Product Change Notification: MFOL-25LWZY479

CCB 6818 Final Notice: Qualification of ASEM as an additional assembly site for selected ATMEGA128x, ATMEGA165xx, ATMEGA169xx, ATMEGA64x, ATMEGA645xx, ATMEGA649xx, ATMEGA329xx, and ATMEGA325xx device families available in 64L VQFN (9x9x1mm) package.

PCN Type: Manufacturing Change

ASCL

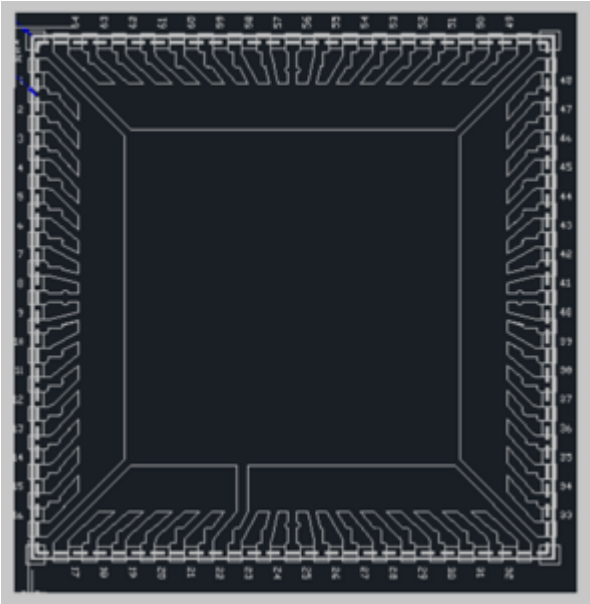
C194

ASEM

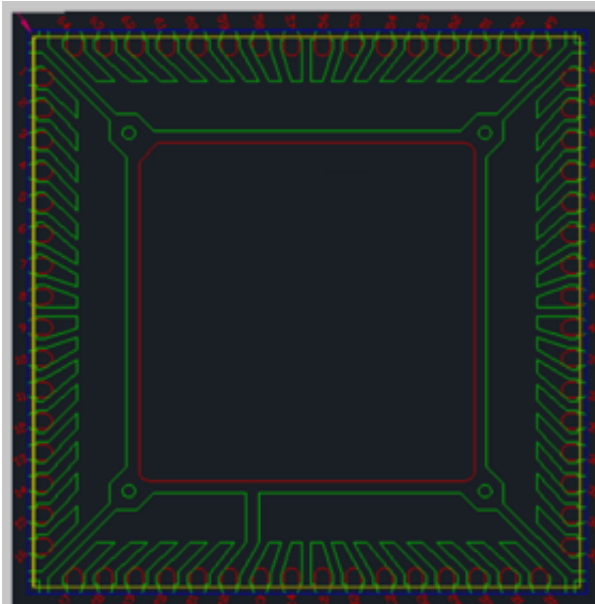
C194FH
